# CITY OF ALBUQUERQUE

**RE: Lot 2 Block 2 Unit 22 Volcano Cliffs SAD 228  
8020 Canoncito Dr. NW  
Grading and Drainage Plan  
Engineers Stamp Date 2/13/17 (D10D003C2)  
Pad Certification Dated 5/30/17**

## DRAINAGE AND TRANSPORTATION INFORMATION SHEET (REV 09/2015)

ENGINEER'S SEAL  2/13/17 DAVID SOULE P.E. #14522	LOZOYA RESIDENCE 8020 CANONCITO DR NW	DRAWN BY: WCVJ DATE: 2-02-17
	GRADING AND DRAINAGE PLAN	21706-LAYOUT-2-01-17
 Rio Grande Engineering 1606 CENTRAL AVENUE SE SUITE 201 ALBUQUERQUE, NM 87106 (505) 872-0999		SHEET # —
		JOB # 21706

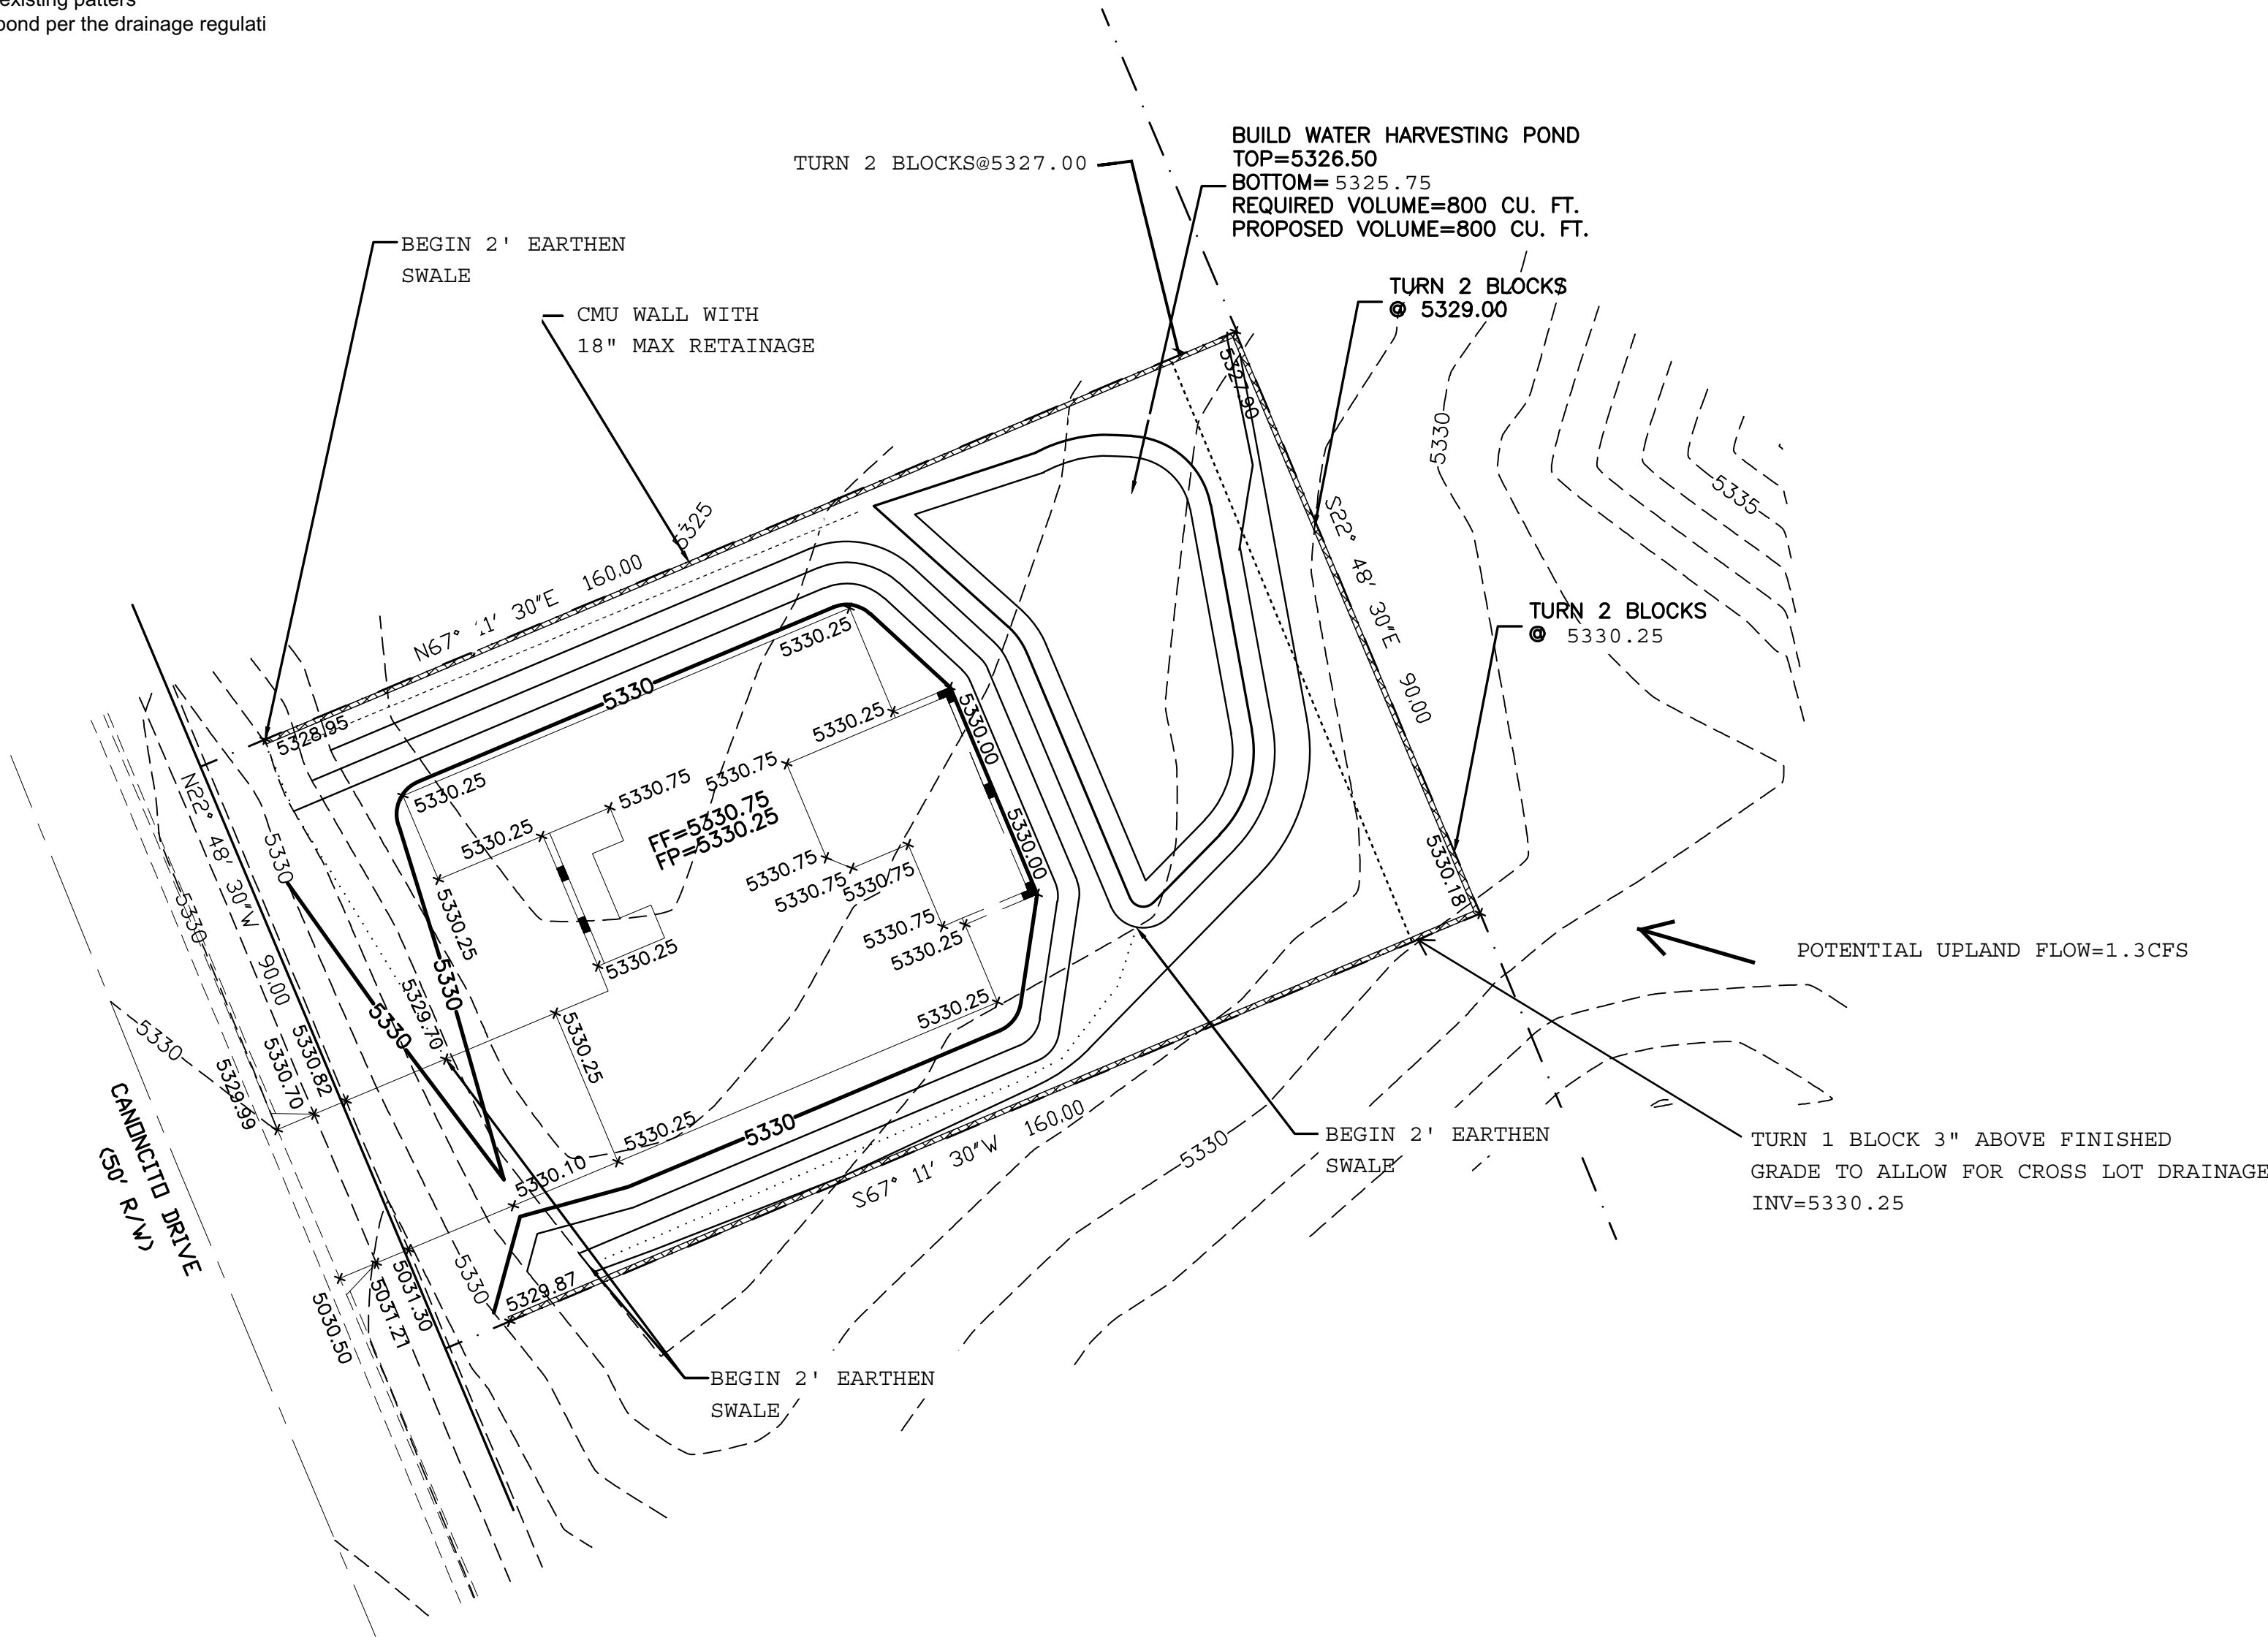
Based upon the information provided in your submittal received 5/30/17, this plan approved for Building Permit.

Please inform the builder to attach a copy of this approved plan to the construction sets in the permitting process prior to sign-off by Hydrology. Also, notify the owner/contractor that a separate permit for any fence is required, and this is the plan to be used for the placement of the fence.

Prior to Certificate of Occupancy release, Engineer Certification per the DPM checklist of this plan will be required.
